**Attachment 4: DPO Comment, Applicant Responses, Department Response in
Proposed Order Crosswalk Tables**

**Attachment 4: Boardman to Hemingway Transmission Line
DPO Comment, Applicant Responses, Department Response in Proposed Order Crosswalk Tables**

Figure 1 – Project Map with Morgan Lake Park Boundary

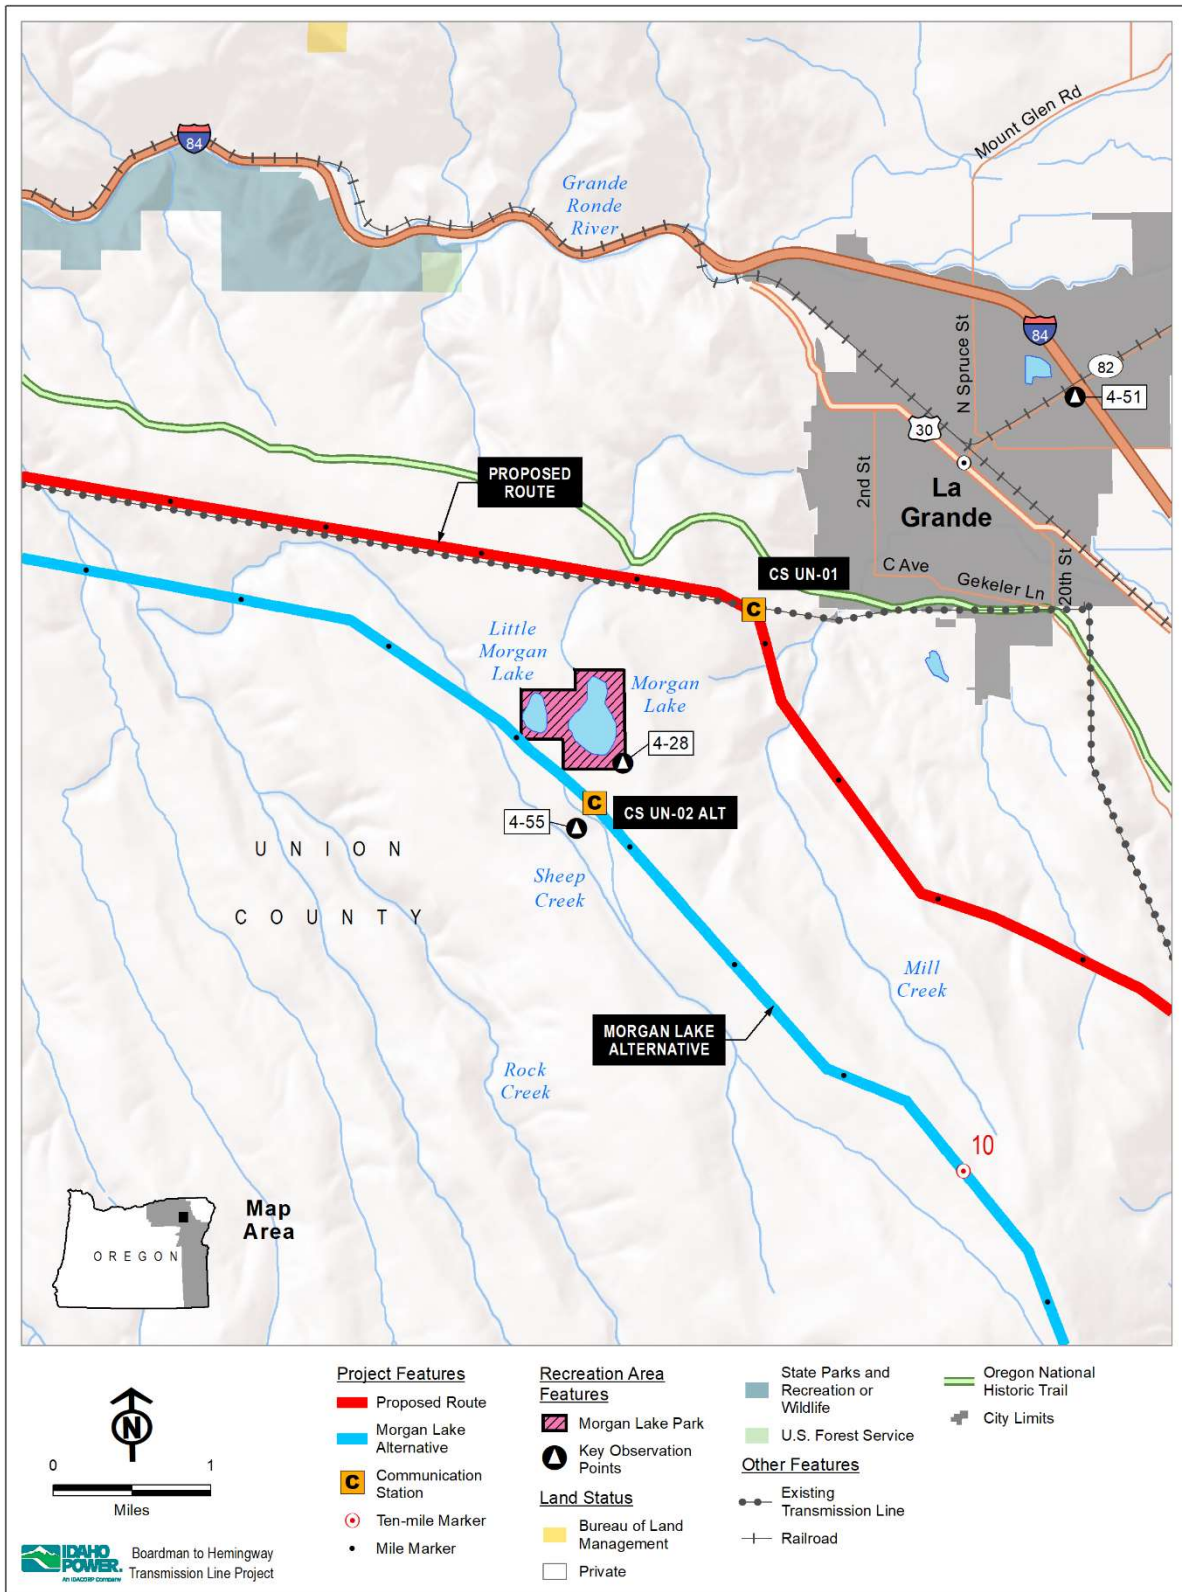
This analysis also assumes that ODOE will require four H-frame towers (ML 7/1, ML 7/2, ML 7/3, and ML 7/4), which are the towers passing closest to Morgan Lake Park per ODOE's Recommended Recreation Condition 1 and Idaho Power's August 22, 2019 DPO Comments. Figure 1 shows the location of Morgan Lake Park with respect to the Morgan Lake Alternative.

Figure 2 – Noise Modeling Results for Morgan Lake Alternative

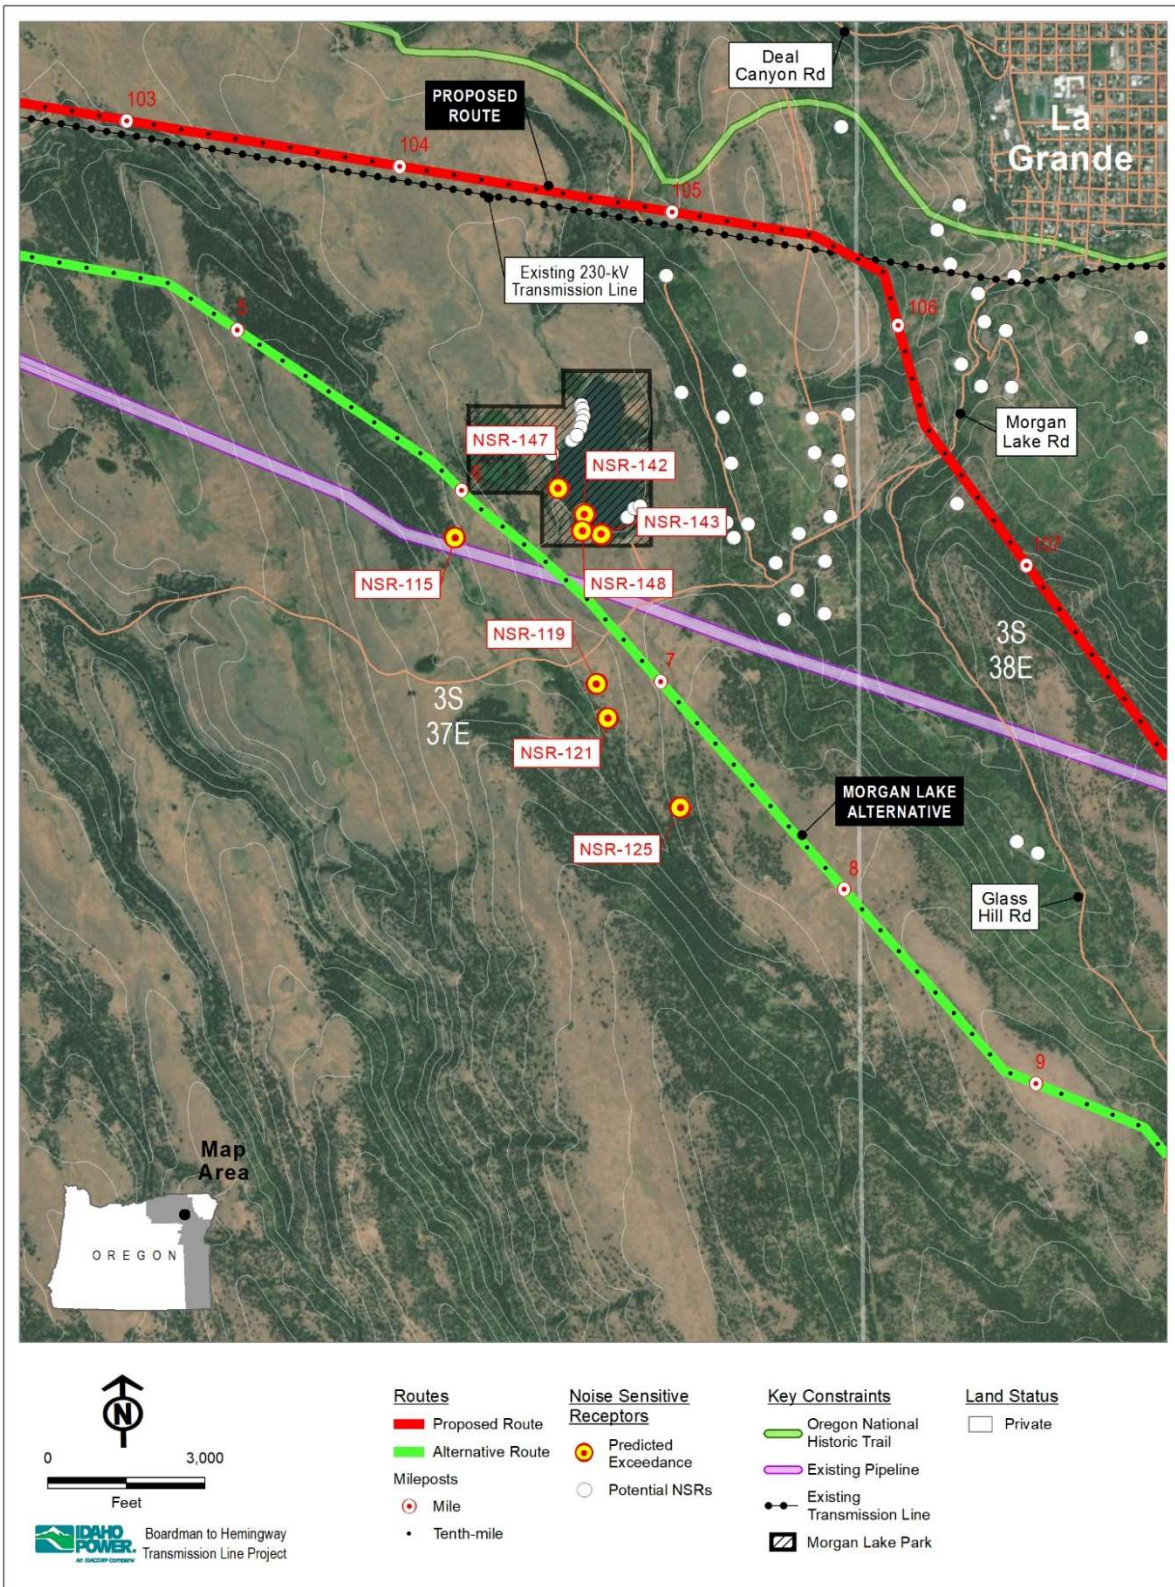
In response to comments received on the Draft Proposed Order (DPO) for the Boardman to Hemingway Project, Idaho Power provides the following information related to potential impacts to Morgan Lake Park, an important recreation opportunity per OAR 345-022-0010. This analysis evaluates potential impacts to the entirety of Morgan Lake Park (204 acres), including Little Morgan Lake (also known as Twin Lake) (see Figure 1). Little Morgan Lake is located immediately west of Morgan Lake connected by a short foot trail and is managed as a wildlife area; there are no recreation facilities at Little Morgan Lake. While the comments primarily focused on visual and noise-related impacts, this response addresses the following four potential impacts, in accordance with OAR 345-021-0010(1)(t)(B):

Figure 5 – Viewshed of ML 6/1 - 6/3, 7/1 - 7/4, 8/1 - 8/2

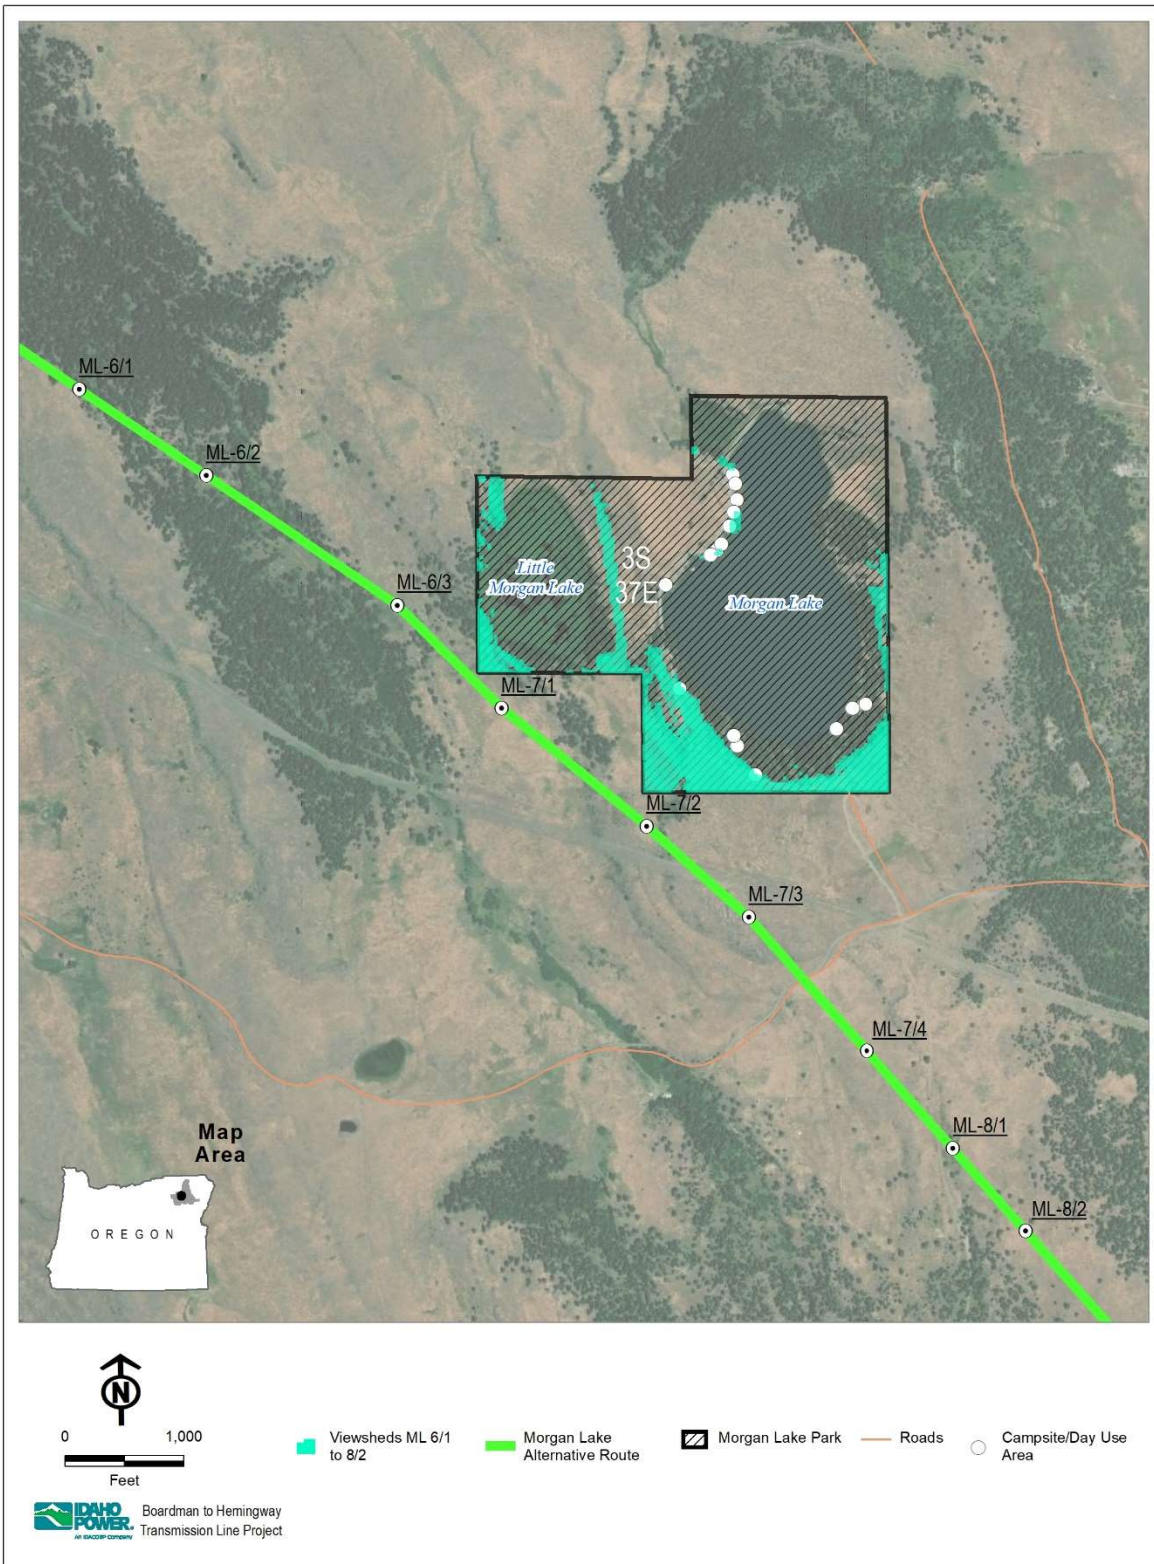
Figures 5 and 6 show the modeled viewshed accounting for trees surrounding Morgan Lake and Little Morgan Lake for the following towers nearest to Morgan Lake Park: ML 6/1, ML 6/2, ML 6/3, ML 7/1, ML 7/2, ML 7/3, ML 7/4, ML 8/1, and ML 8/2. Light green shading depicts areas within the Morgan Lake Park boundary where at least some portion of one of the above listed transmission towers would be visible.

Figure 6 – Viewshed of ML 6/1 - 6/3, 7/1 - 7/4, 8/1 - 8/2 (zoomed in)

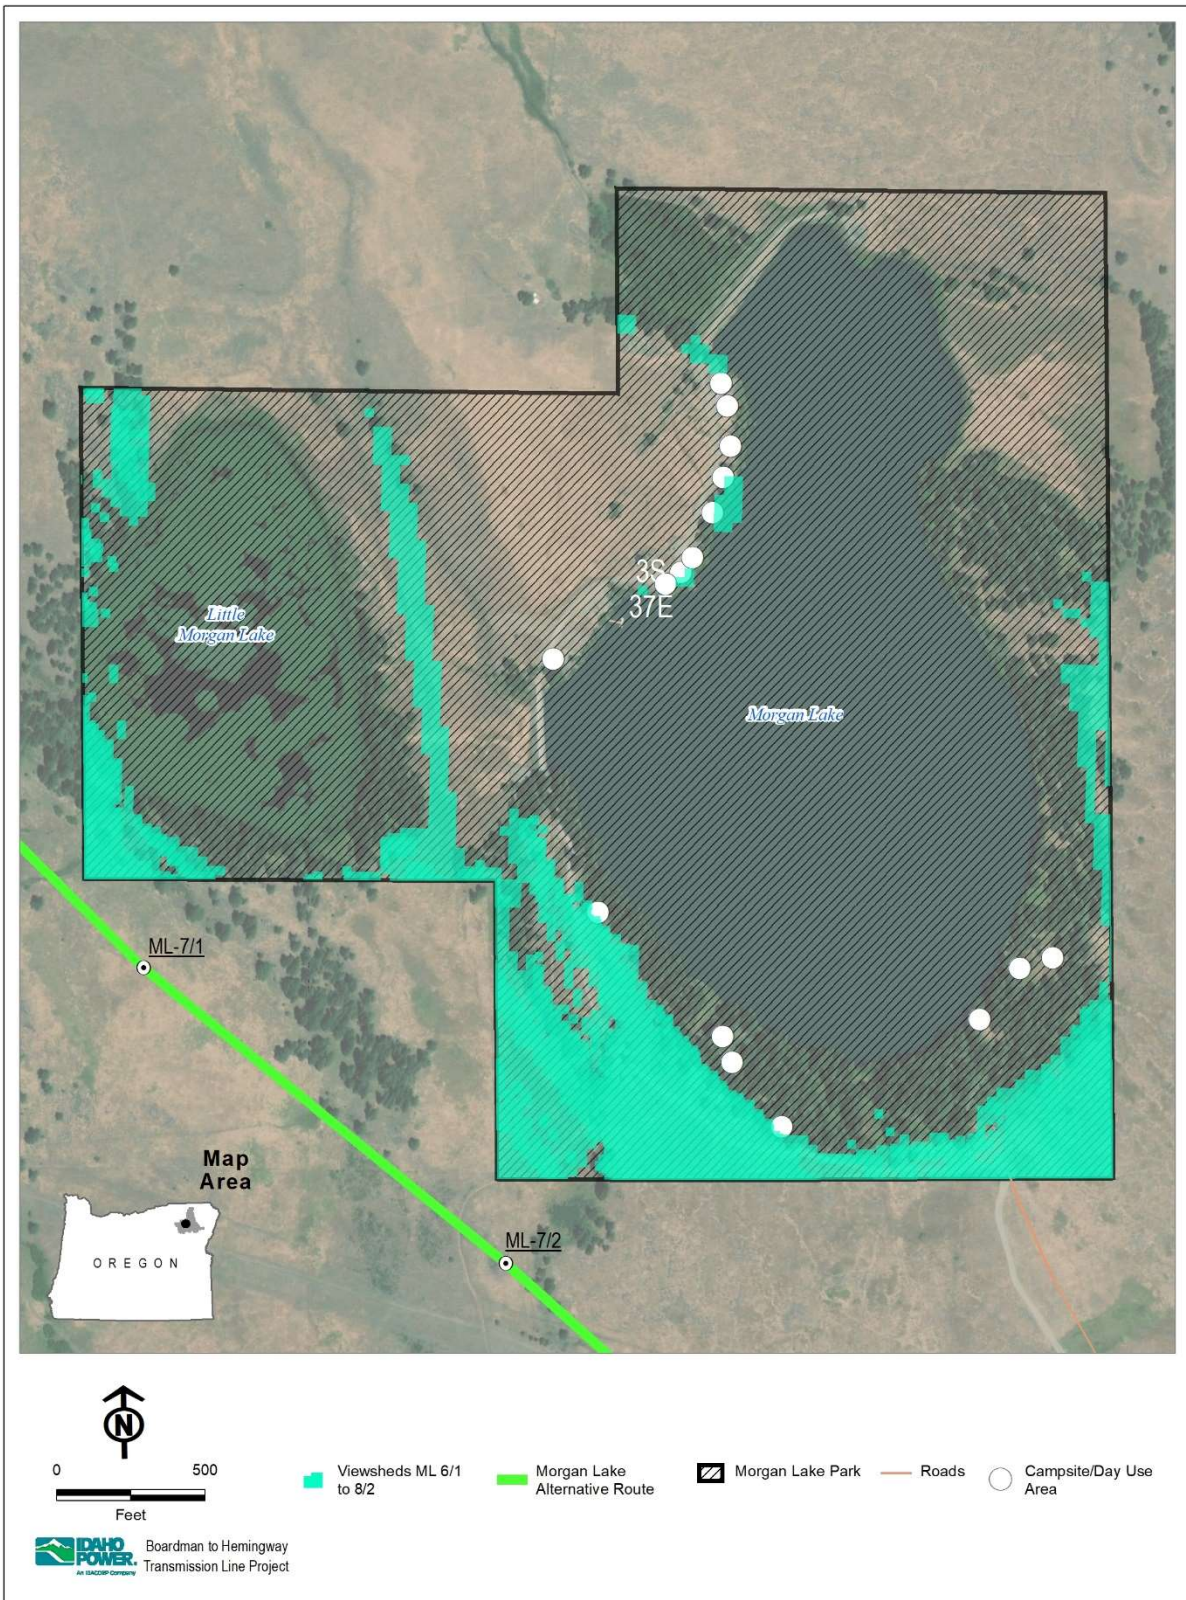
Around Morgan Lake, vegetation would effectively screen views of the transmission towers except for a few discrete locations along the western shore. No towers would be visible from the floating dock (see Figure 3 and Figure 8). Towers would not be visible from the campsites themselves along the southern shore of Morgan Lake, although the towers would be visible from the campsite parking areas.
